Dye TRACER STUDY

October 13, 2006

RE: Responses to NMED comments of the Ciniza Refinery Dye Tracer Study

**FIGURE 1**  
**STORMWATER / NON-PROCESS**  
**WASTEWATER SEWER SYSTEM**  
 2006

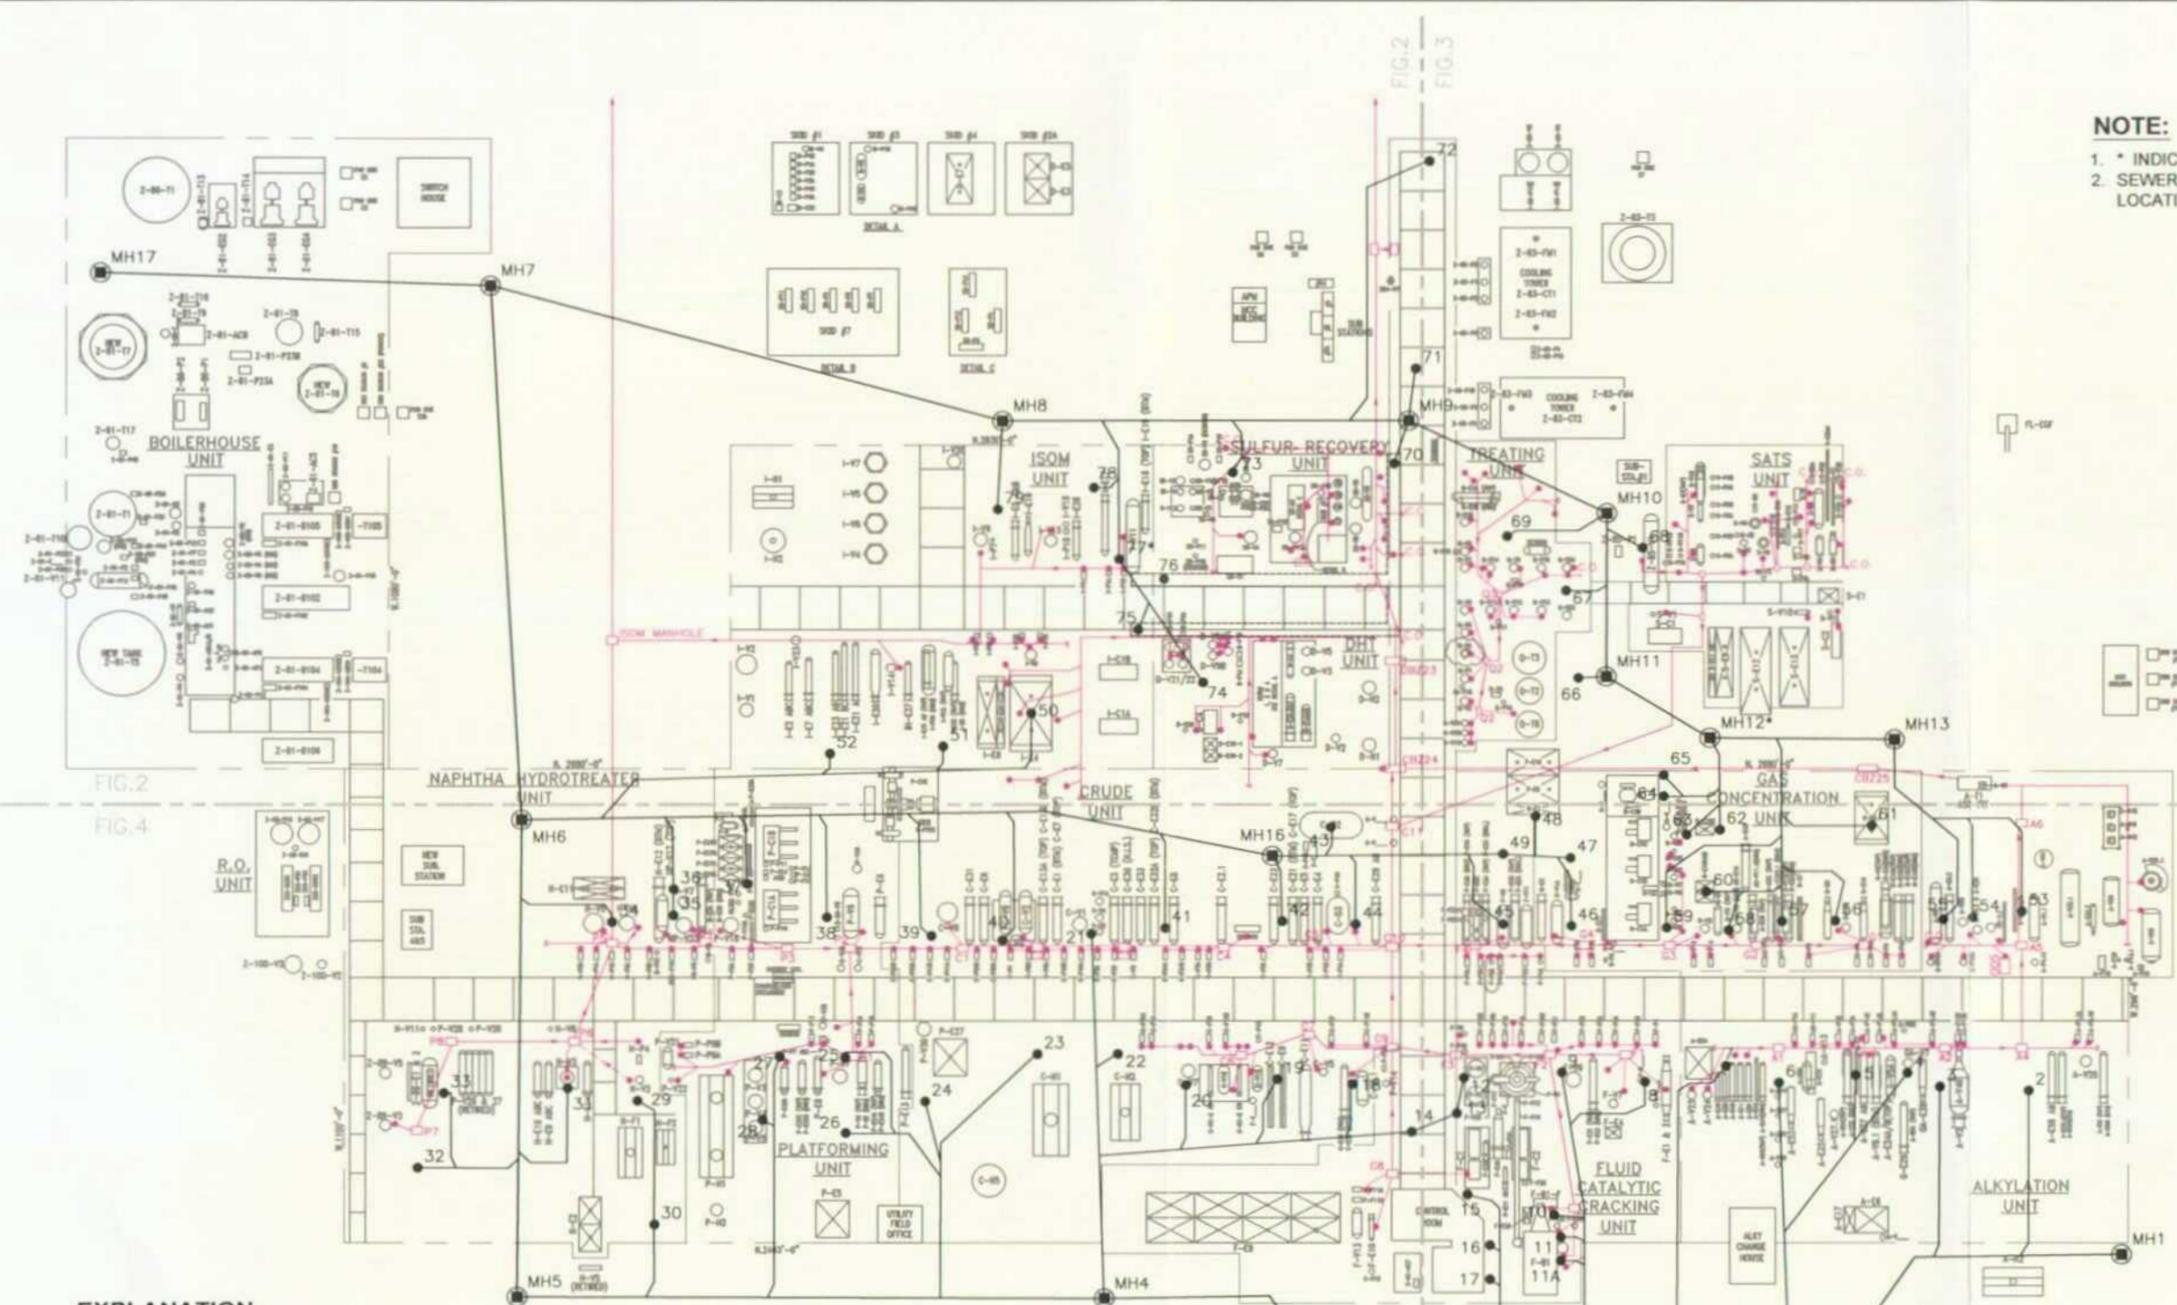
It is unclear from the Figures provided in the Report where the process sewer system is in relation to the stormwater/non-process wastewater sewer system. An overlay map showing the two sewer systems would be beneficial. (e.g. it is not clear where MH17 in Figure 2 would appear in Figure 1).

*Please see Figure 1 attached to this letter. Figure 1 shows the process sewer drain locations and the stormwater sewer drain locations on a Master Plot Plan of the Ciniza Refinery. The process sewer is designated by magenta lines and the storm sewer is designated by black lines.*
